Determination 2015/049

Regarding the refusal to issue a code compliance certificate for alterations to an existing house at 43 Waikaraka Drive, Te Puna

This determination considers the compliance of alterations to a house to extend an existing deck drain through roof space to a gutter, and the particular jointing method used. The determination discusses the required durability for the deck drain and considers current and future performance.

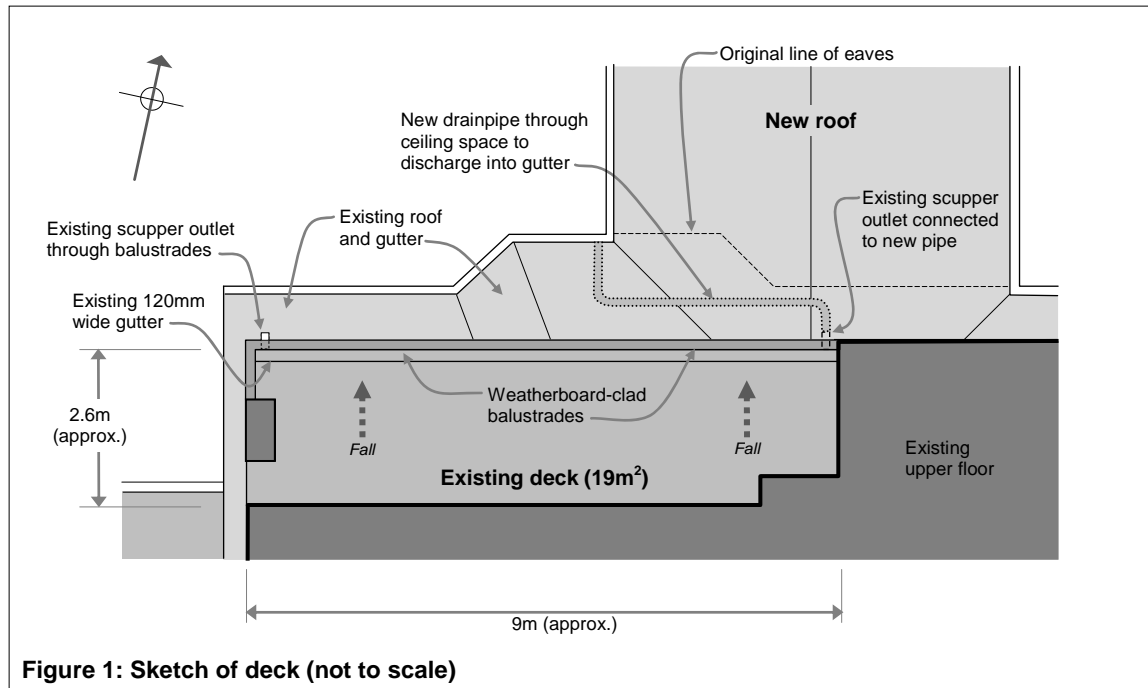
- 2.3.1 The 2014 alterations included a single-storey timber-framed addition to the east to form a semi-outdoor dining area ("the dining addition"). The roof to the new dining area intersects with the original lower roof, blocking one of the original outlets to the existing deck as shown in Figure 1 (over page).

- 2.4.1 The existing membrane deck floor falls towards a full-length 120mm wide membrane-lined gutter at the front edge, which drains to 90mm x 65mm scupper outlets at both ends. The west outlet remains unchanged, while the east outlet is re-routed through the lower roof space to discharge into the gutter.
